EAST + NORTH ELEVATIONS - PROPOSED
70 HIGH STREET, LITTLEHAMPTON, SUSSEX.
GRAHAM NICOLLS LTD.

SCALE / 1:100 @ A3
DATE / 12.06.2018
DWG. NO. / 080418 / TP.04 'C'

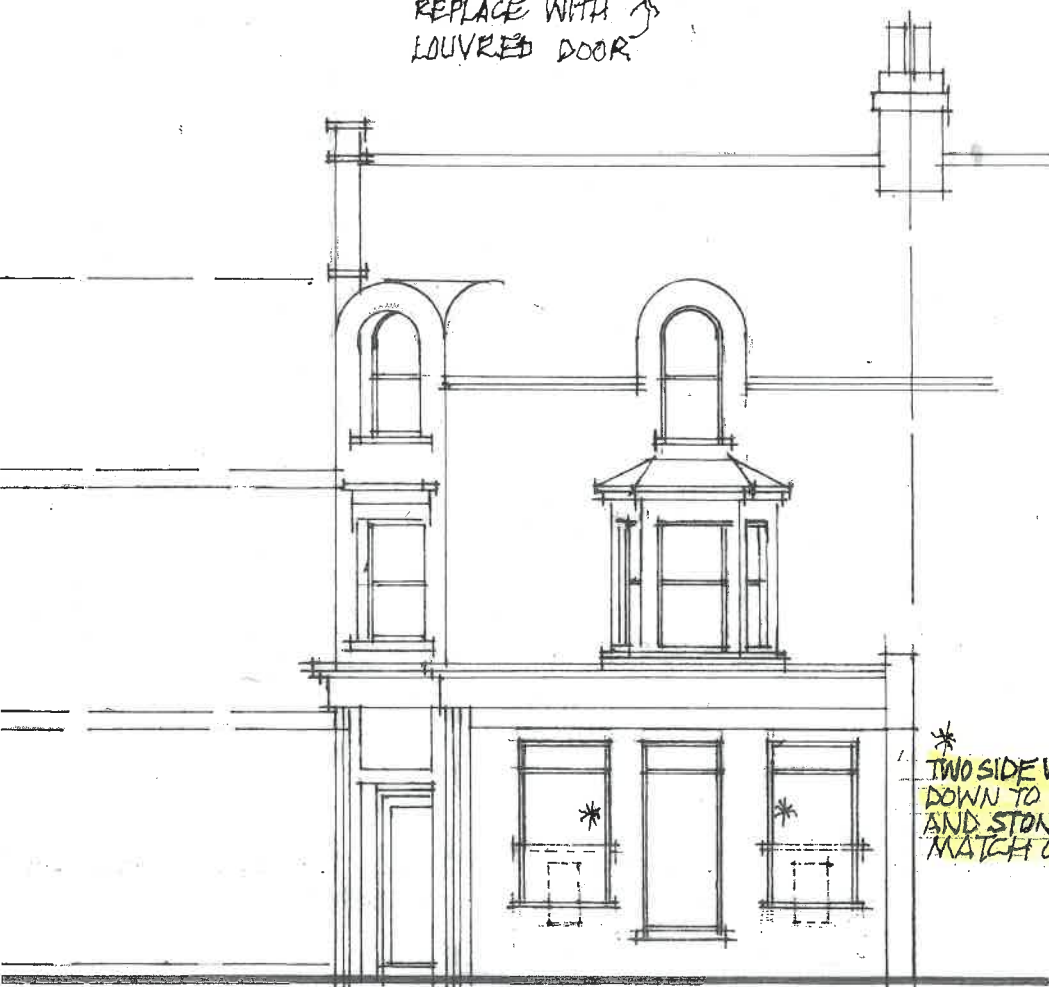
REPLACE WITH
LOUVRED DOOR

* NEW DOOR + WINDOWS

* REMOVE WINDOW
INFILL AS "BLIND WINDOW"

* TWO SIDE WINDOWS TO BE EXTENDED
DOWN TO LINE OF ORIGINAL CILLS
AND STONWORK ALTERED TO
MATCH ORIGINAL

REV. C - 22.10.2018 / SIDE WINDOWS OF NORTH SHOP
ELEVATION CILL LINES ALTERED.
REV. B' - 28.08.2018 / BACK DOOR TO SHOP ADDED + FASCIA REMOVED
REV. A' - 20.08.2018 / NEW G/F DOOR ADDED
ON EAST ELEVATION.
